# HISTORIC AND DESIGN REVIEW COMMISSION

**HDRC CASE NO:** 2018-601  
**ADDRESS:** 639 MISSION ST  
**LEGAL DESCRIPTION:** NCB 2914 BLK 3 LOT 21 22, S 10 FT OF 20  
**ZONING:** RM-4,HS  
**CITY COUNCIL DIST.:** 1  
**DISTRICT:** King William Historic District  
**LANDMARK:** House  
**APPLICANT:** Fernando Morales/Candid Rogers Studio  
**OWNER:** Mike Villareal, Jeanne Russell  
**TYPE OF WORK:** Exterior modifications to rear accessory structure  
**APPLICATION RECEIVED:** November 20, 2018  
**60-DAY REVIEW:** January 19, 2018  
**REQUEST:**

The applicant is requesting a Certificate of Appropriateness for approval to modify the façade and fenestration of an existing rear accessory structure.

# 1 DEMOLITION FLOOR PLAN

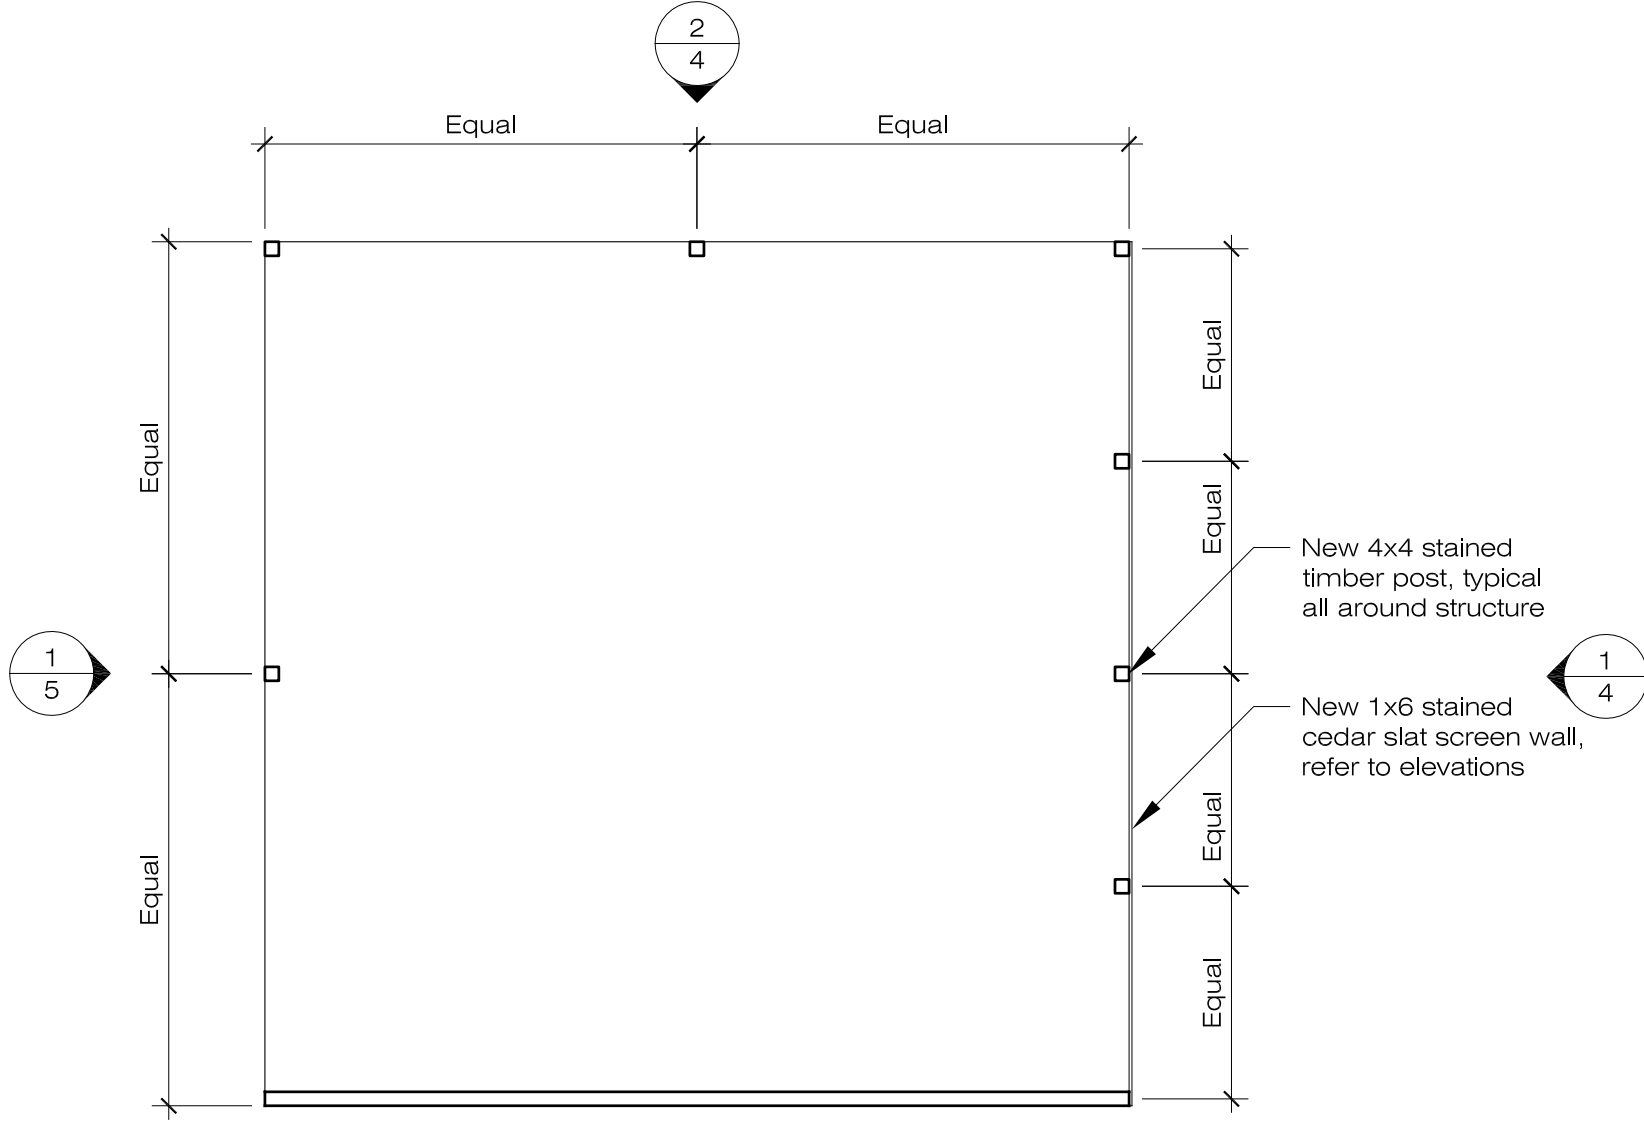
- b. **ELEVATION MODIFICATIONS** – The applicant has proposed to modify three of the four existing elevations of the rear accessory structure. The west elevation will remain intact. The existing north and south walls will be replaced with new 4x4” stained timber posts clad with 1x6 stained cedar slats to create a semi-open, screen-like appearance. The east elevation will be replaced with three 4x4” stained timber posts. According to the Historic Design Guidelines, existing outbuildings and their distinctive features should be repaired in-kind. When new materials are needed, they should match existing or original materials in color, durability, and texture. The existing siding is non-original to the structure. Historically, the structure functioned as an automobile garage and likely featured woodlap siding based on the historic development pattern of the district. The proposed use of cedar posts and slats is a modern reinterpretation of woodlap siding. Staff finds the elevation modifications appropriate based on these structure and site-specific conditions.
